**7-G-22-HZ**  
**APPLICATION FOR CERTIFICATE OF APPROPRIATENESS**

1203 Luttrell St. 37917  
 Fourth and Gill H

# Staff Report

File Number: 7-G-22-HZ

**DORMER FACING WELLS**

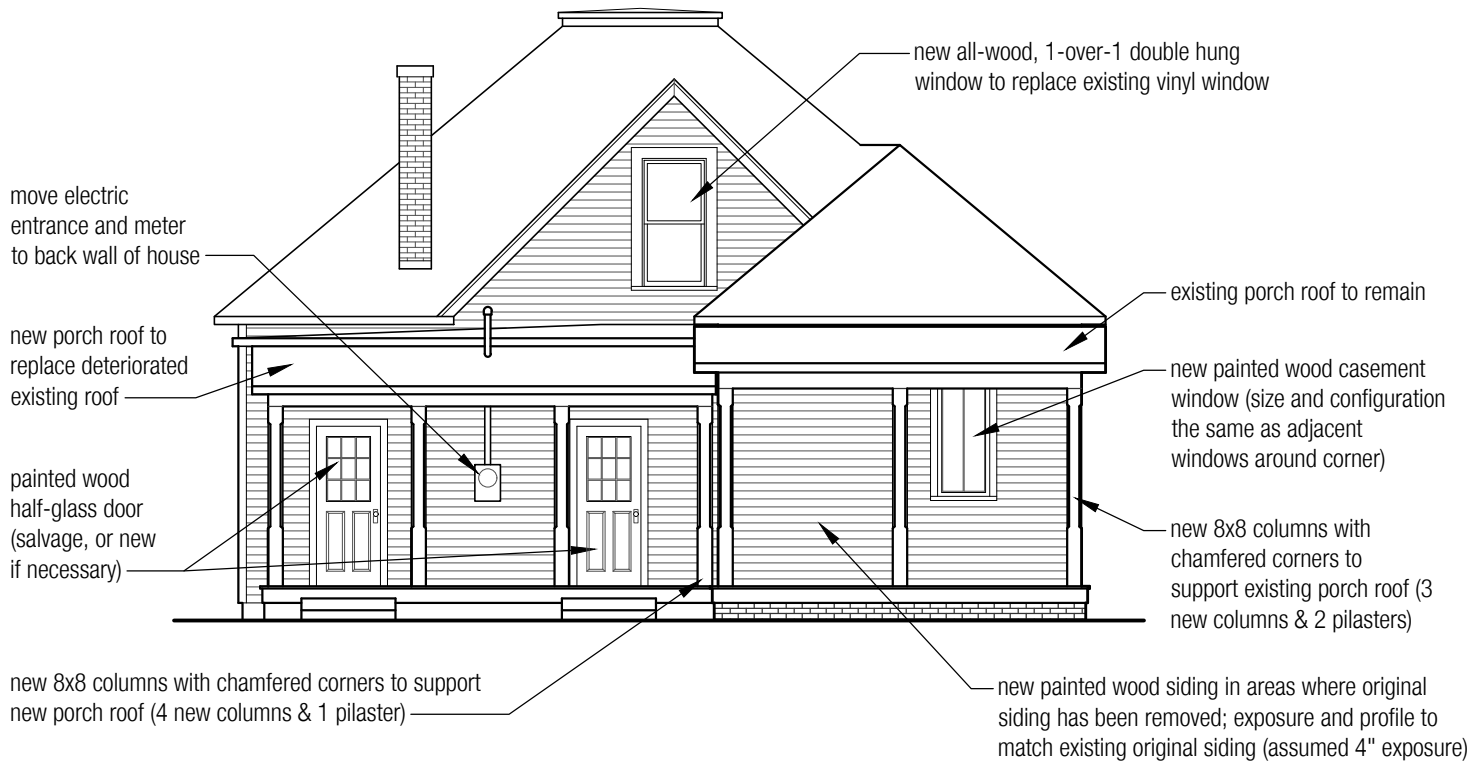
existing dormer window is deteriorated; replace with new all-wood casement window if repair is deemed unfeasible (appearance to match existing)

existing dormer window is deteriorated; replace with new all-wood casement window if repair is deemed unfeasible (appearance to match existing)

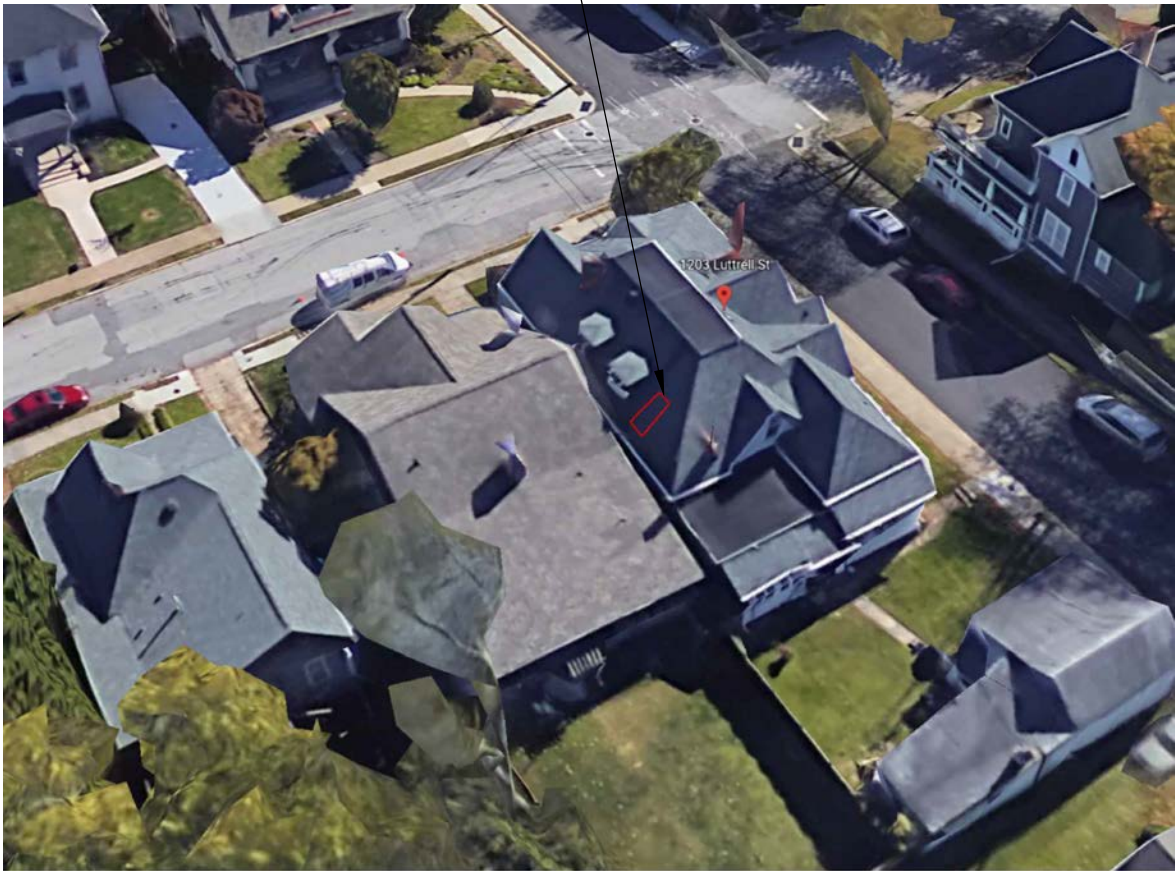
non-original addition

enclosed back porch

proposed egress skylight on north  
roof slope

3. The installation of a flush skylight on the proposed roof slope will not have an effect on historic materials, will not be visible from the public right-of-way, and will not alter the overall roofline of the house.

4. The proposed rear porch does not require the removal of original features, and the new porch will be modest in design and compatible with the original period of the house.

PROPOSED GARAGE CHANGES

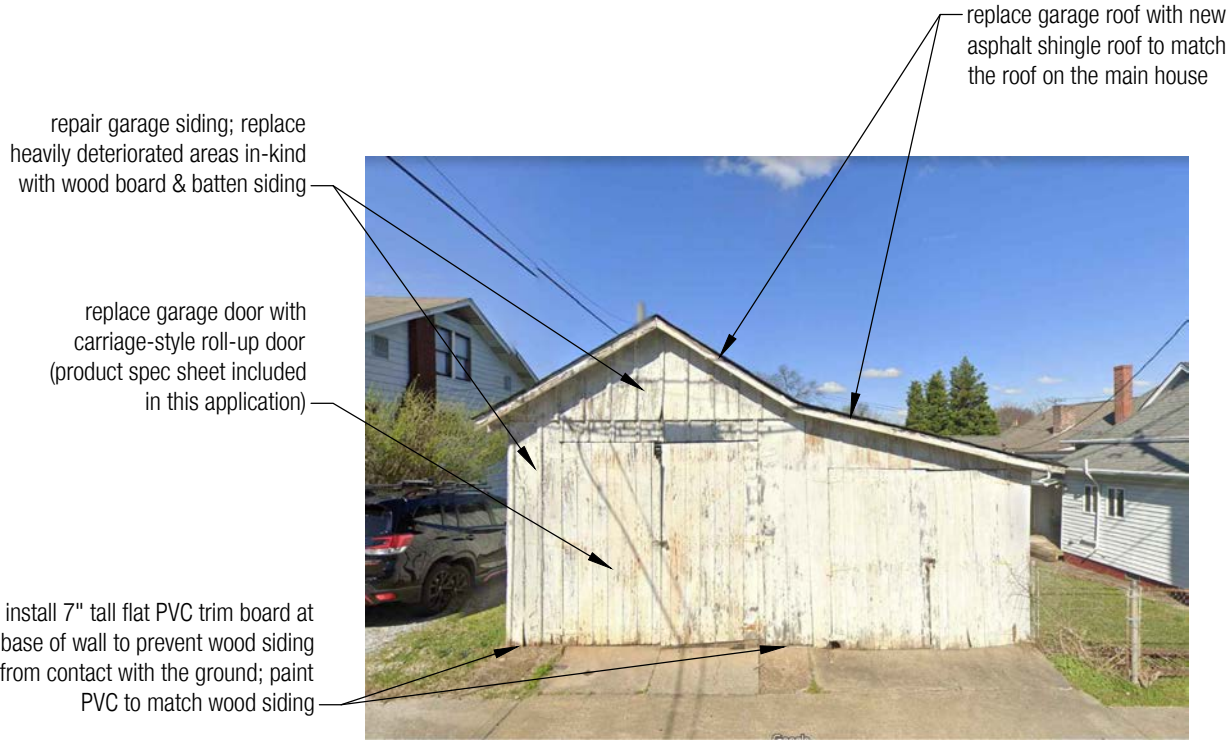
Garage: repair and replacement in-patches with wood board-and-batten siding; replacement in-kind of asphalt shingle roof; replacement of flush panel wood double doors with carriage-style roll-up door (to reflect specifications in application).

5. Basic repair and in-kind replacement to the secondary structure meets the design guidelines, and will allow the owners to retain a unique historic secondary structure which could not be reconstructed in the same design and location, were it demolished. The proposed replacement garage doors meet the design guidelines.

Design 11, 31, or 36 will be selected and submitted in detail prior to installation
